Determination 2011/081

Regarding the refusal to issue a certificate of acceptance for repairs to a tiled deck on a house at 58 Columbia Crescent, Beachlands, Auckland

2.3 The 23m² deck is situated partly over ground floor rooms as shown in Figure 1:

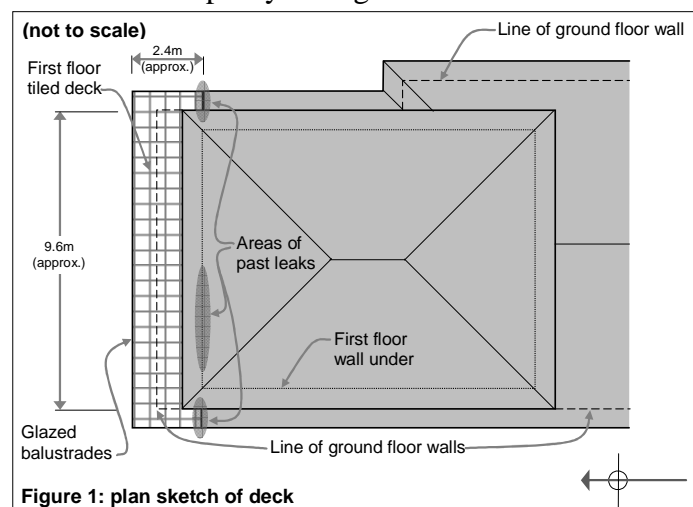
- There is no drip edge at deck edges, allowing water to run directly down the fascia. Coarse filler, applied around balustrade posts and along the upper part of the fascia up to the tile edge, is absorbing and holding moisture.

- This is confirmed by signs of moisture, and elevated moisture readings in the deck soffit framing indicate that the outer section of the deck floor is not currently weathertight.

- Falls across the deck vary from 0.5° to 0.9° which, while generally providing a positive fall, is below the minimum 1° fall specified in E2/AS1. There is also evidence of ponding in one area, with efflorescence and wet tile grout.

- While falls along the deck are generally more than 1.2°, which is above the minimum 1° fall specified in E2/AS1, this does not speedily shed water due to the 9.6m length of the deck.

- Although roof to deck junctions have been repaired, the new roof parapet does not incorporate saddle flashings where it meets the walls.
- Construction photographs indicate that the original membrane and upstand appeared to have lost adhesion due to the leaks into the plywood. However the new membrane is applied over the original upstand at this critical junction.

- The lack of staggered joints and nail-fixing the fibre-cement underlay may allow undue movement at sheet joints. However, it is not possible to assess the reinforcement (if any) of underlay joints or the new membrane's condition.

- The 9.6m length of the deck floor does not incorporate movement joints within the tiled surface, although suppliers of tile adhesives commonly recommend

the installation of movement joints at a minimum of 3 metre centres for larger tiles to accommodate increased stress to the decreased number of joints.

- the lack of fall across the deck, with ponding in one area
- the lack of control joints, with cracks to some tile joints
- the nail-fixing of the new fibre-cement underlay allowing undue movement
- the lack of drip edges at deck edges and drainage gaps at balustrade posts
- the lack of saddle flashings at the new roof parapet to deck junctions
- uncertainty regarding:
 - reinforcement to the unstaggered underlay joints
 - joining the new membrane to original deteriorated membrane upstands
 - drainage holes added to existing joinery.
